Calderwood Modification 4 to Part 3A Concept Plan – Detailed response to submissions - Biodiversity

Lendlease Communities (Calderwood) Pty Ltd

Table 1: Detailed responses to Wollongong City Council submission

Figure 1: Key Fish Habitat within the study area and locality (source: NSW DPI)

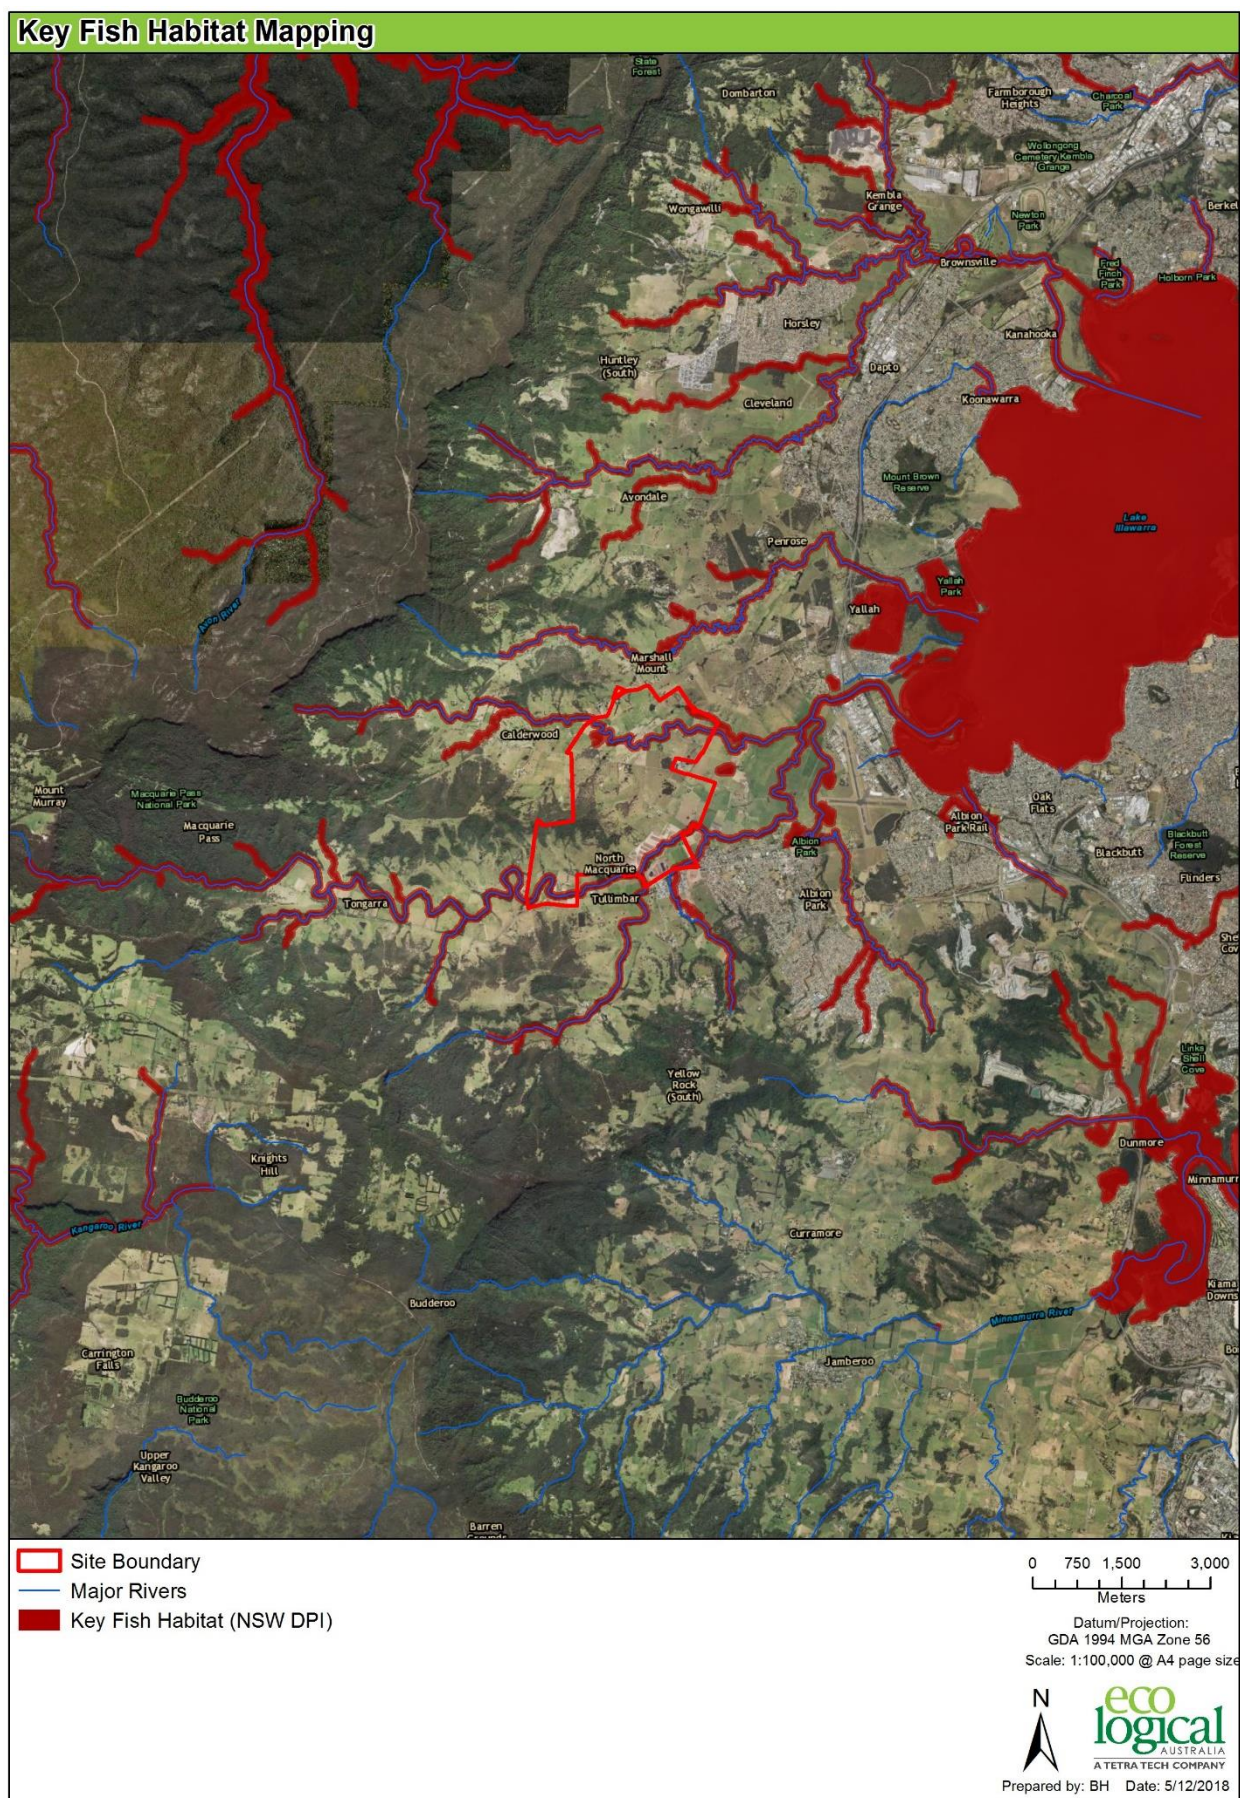
<p>There is no mention or assessment of potential impacts to DPI mapped Key fish habitat of Marshall Mount Creek, Macquarie Rivulet and Lake Illawarra in accordance with the Policy and guidelines for fish habitat - conservation and management (DPI, 2013) in the Ecological (2018) report.</p>	<p>Marshall Mount Creek and Macquarie Rivulet are mapped as Key Fish Habitat and would likely be classified as Class 2 – Moderate Key Fish Habitat. Portions of these watercourses are located in the study area. No development within the Key Fish Habitat areas are expected, and the implementation of measures to manage indirect impacts would be implemented. These include the management of water quality, restoration and improvement of riparian vegetation along waterways and removal of significant agricultural nutrient inputs. If any impacts to Key Fish Habitat were to occur, a permit under Section 200 / 201 of the <i>Fisheries</i></p>

Issue raised	Response
	<p><i>Management Act 1994</i> would be required at the DA stage. However, impacts on these habitats are not expected and would be actively avoided to minimise any potential harm to the environment.</p>
<p>It is clear that Marshall Mount Creek, Macquarie Rivulet and Lake Illawarra are important aquatic habitats and significant and ecologically sensitive areas. Consistent with Actions of the Illawarra-South Coast Regional Plan (I-SRP, DPE 2015), although the SEAR's require inclusion of Lake Illawarra in the impact assessment, the study area of the aquatic ecology impact assessment has generally overlooked Lake Illawarra. The statement by Ecological (2018) that 'The lake [Lake Illawarra] is an important ecological and recreational feature in the region and some of the fringing wetlands are unlikely to be influenced by flows from this site.' presents a vague impact assessment and needs clarification eg identify (by mapping) what CM Act Coastal wetlands, Key fish habitat and DPI (2009) mapped seagrass beds in Lake Illawarra are likely to be impacted and what would be the severity and timeframe for the impacts.</p>	<p>Key Fish Habitat is mapped along Marshall Mount Creek and Macquarie Rivulet in the development footprint (Figure 1). The Coastal Management SEPP maps Marshall Mount Creek as a Coastal Wetland (Figure 2). There are no estuarine macrophytes mapped within the development footprint. The closest aquatic macrophytes are mapped along the edges of Lake Illawarra (Figure 3). Direct impacts on coastal wetlands, estuarine macrophytes or Key Fish Habitat is not expected. Indirect impacts would be managed through a range of environmental management measures implemented throughout the life of the project.</p> <p>These would include sediment and erosion control measures prior to and during construction, implementation of Vegetation Management Plans, water sensitive urban design (WSUD) features to treat hard surface runoff, prevention of runoff into existing waterways, flood management measures and strategic placement of water quality basins. These decisions have been based on the results of numerous studies including a Water Management Study (Cardno 2010), Flood Study (Rienco Consulting 2010). Floodplain Risk Management Study (Cardno 2011), Groundwater Assessment (Douglas Partners 2010) and the updated Watercycle and Flood Management Strategy Update (JWP 2019).</p> <p>The Water Management Study concluded that the WSUD features implemented would improve stormwater quality for any water originating at the site, and reduce pollutant loads such that they would meet the annual load reduction targets (Cardno 2010). The management of pollutant loads, and stormwater runoff described, are consistent with the national water quality guideline Australian Runoff Quality and meet the then Director General's Requirements for water quality and water sensitive urban design related issues (Cardno 2011).</p> <p>The Watercycle and Flood Management Study assessed the impact of increased lot yield on flood impacts (JWP 2019). The study concluded that an increase in lot yield would increase the pollutant loads generated from the development. However, water quality objectives can still be met by increasing the size of treatment devices within some areas in the footprint. Updated modelling of expected pollutant loads into wetlands 6a, 6b and 6c concluded that the current size of the wetlands was sufficient to support an increased pollutant load and ensure that minimum water quality objectives are still met (JWP 2019). In addition,</p>

Figure 4: Groundwater dependent ecosystems in the development footprint and locality (Source: Bureau of Meteorology 2018)

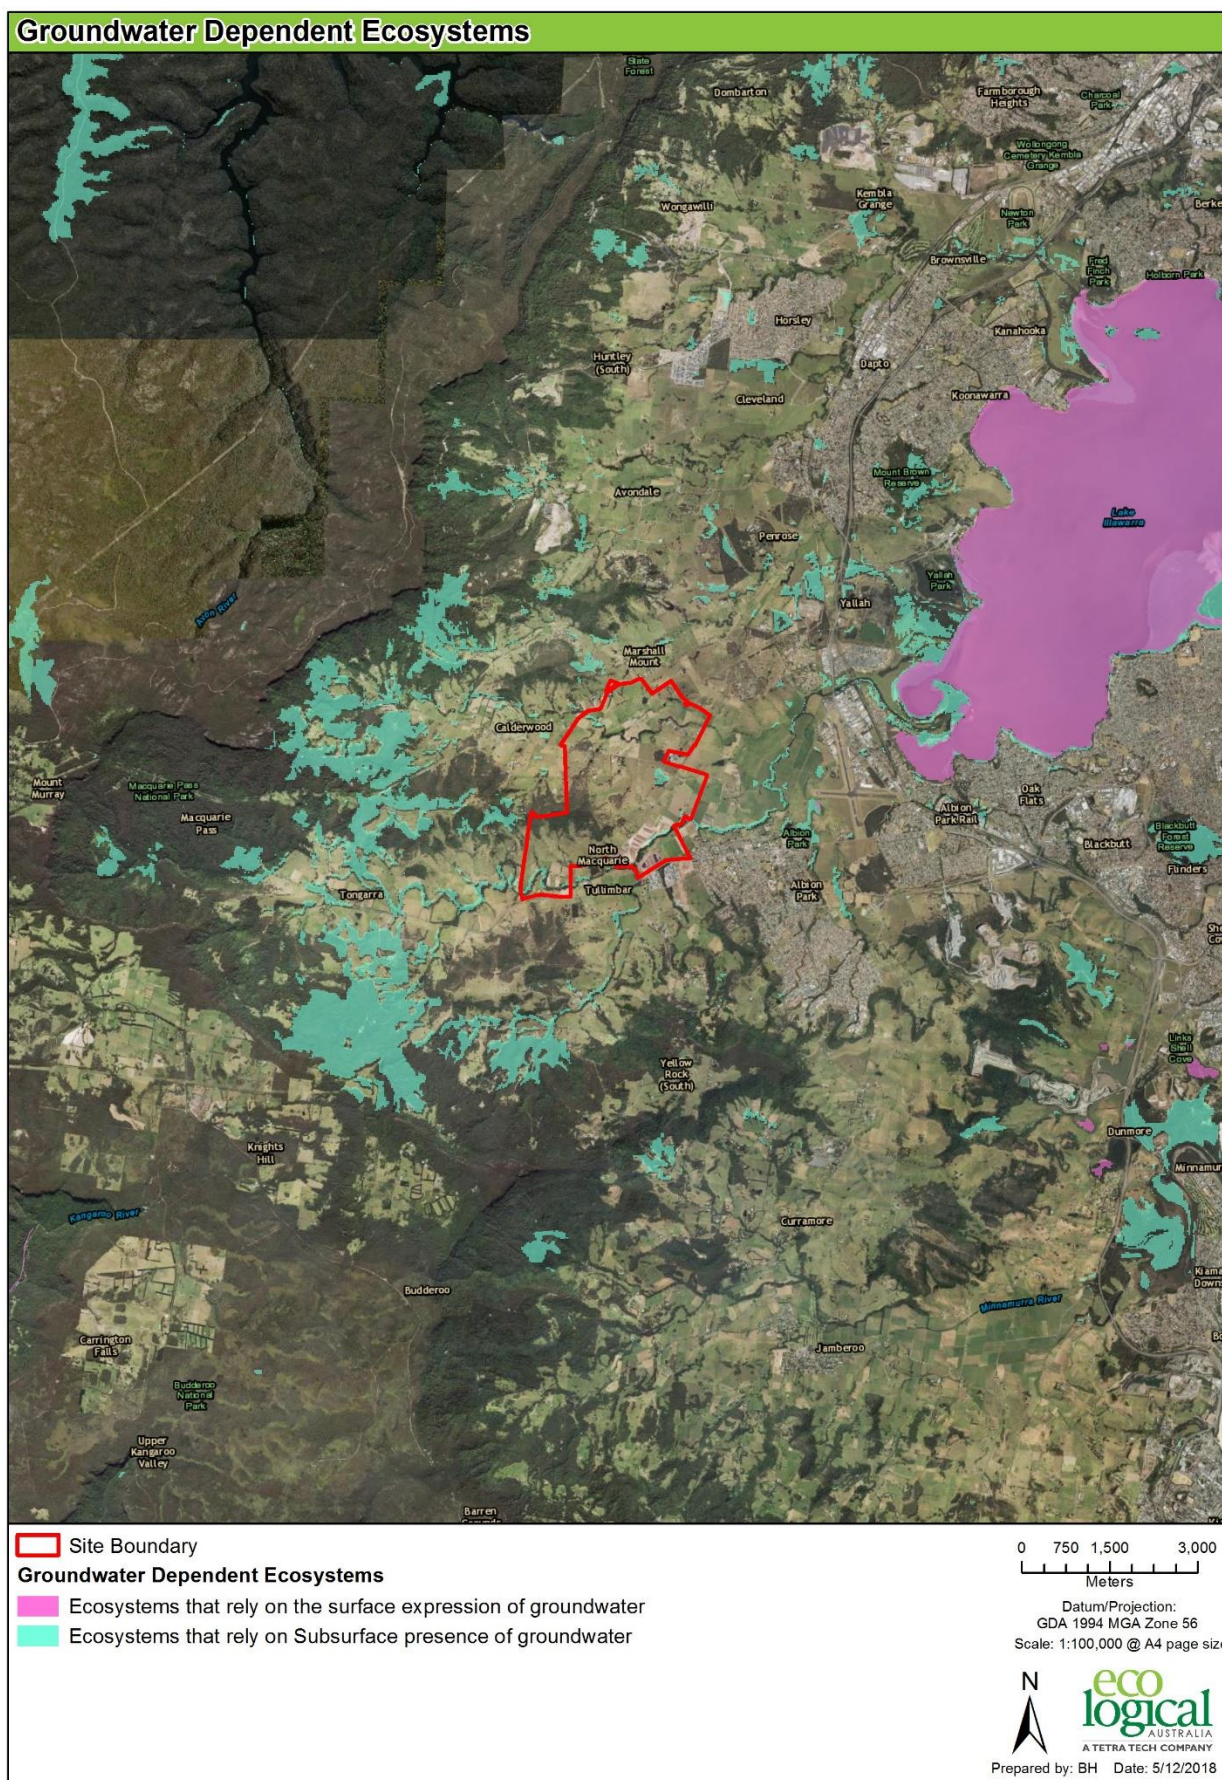
<p>The EA by Ethos Urban (2018) states that 'Flows to and from terrestrial groundwater dependent ecosystems are expected to be maintained'. This statement does not appear to have basis as the EA also notes that the detailed impact assessments on groundwater and therefore GDE's [sic] (such as the aquatic ecosystems of Marshall Mount Creek, Macquarie Rivulet and Lake Illawarra) have not been completed.</p>	<p>The development footprint poses a low – moderate risk with respect to groundwater. The Concept Plan Modification Comment (Douglas Partners 2018) and Watercycle and Flood Management Strategy Updates (JWP 2019) are consistent in their conclusions that the proposed increase in yield would be unlikely to affect GDEs, assuming that detailed design for areas above RL-20 is undertaken at the DA stage. These assessments have remained consistent with the initial Water Cycle Management Study (Cardno 2010), Flood Modelling Report (2011) and Groundwater Assessment (2010) initially prepared for the CUDP. The Ethos Urban Statement is based on these results and the recommendation that detailed study is undertaken for areas of moderate groundwater risk and is therefore consistent with the results of the technical studies.</p> <p>A site inspection by Dr Peter Hancock on 3 April 2019 revealed that the reaches of Marshall Mount Creek and Macquarie Rivulet that are dependent on groundwater (Figure 4) occur at the upstream end of the Project boundary. Therefore, recharge of the aquifer supporting these river baseflow GDEs will occur outside of the area proposed for fill.</p>

Issue raised	Response
<p>The conclusion 'Below RL 20 or in localised low lying areas adjacent to creek-lines, groundwater may present itself as a moderate constraint due to its proximity to the ground surface. This will require further assessment in the subsequent development stages.'</p>	<p>This conclusion was made by Douglas Partners (2010) in their Groundwater Assessment. As above response indicates, the conclusion in the updated report by Douglas Partners (2018) is consistent with the conclusions made in 2010.</p>
<p>Local groundwater present in 'shallow aquifers' generally 'contained in the alluvial deposits of Marshall Mount Creek and Macquarie Rivulet' and 'limited by the underlying bedrock' (Douglas Partners, 2010) are considered likely to be providing base flow into both waterways (i.e. base flow stream ecosystem). This hydrological connectivity is considered to form an important functional element in the maintenance of the aquatic biodiversity values and services and the persistence of the Marshall Mount Creek and Macquarie Rivulet GDE's [sic]. It's clear from the preliminary geotechnical investigations that there is a very high probability of alteration of spatial and temporal flows into the shallow aquifers and GDE's [sic] these are expected to support.</p>	<p>The reaches of Marshall Mount Creek and Macquarie Rivulet that are dependent on groundwater (Figure 4) occur at the upstream end of the Project boundary, so recharge of the aquifer supporting these river baseflow GDEs will occur outside of the area proposed for fill. The Groundwater Assessment concluded that areas of above RL-20 (i.e. areas of alluvial deposits) would require careful planning when deep cuts (>2m) are expected to occur (Douglas Partners 2010).</p> <p>Further, this risk was considered a moderate groundwater constraint (Douglas Partners 2010). The Assessment also concluded that with careful planning at these stages and strategic placement of basins, impacts on above RL-20 could be avoided. Increased flows from hard stand surfaces is expected, however these would be managed through measures outlined in the Water Cycle Management Study (Cardno 2010). The updated Watercycle and Flood Management Study assessed the impact of increased lot yield on flood impacts (JWP 2019). The study concluded that utilising the latest TUFLOW model and WSUD model the increase in lot yield would still meet water quality objectives, would not alter flow regimes and would not increase flood risk (JWP 2019).</p> <p>Provided appropriate groundwater and water cycle management measures are implemented development in areas of above RL-20 changes to spatial and temporal flows would be minimal and would not significantly affect the GDEs. This is because most of the recharge areas occur outside the project area and the use of compacted material in the floodplain was approved in the Concept Plan. Compacted fill is likely to intercept rainwater. However, the use of compacted fill has not arisen due to this proposed increase in yield. The use of fill is consistent with the Approved Concept Plan and subsequent modifications.</p>
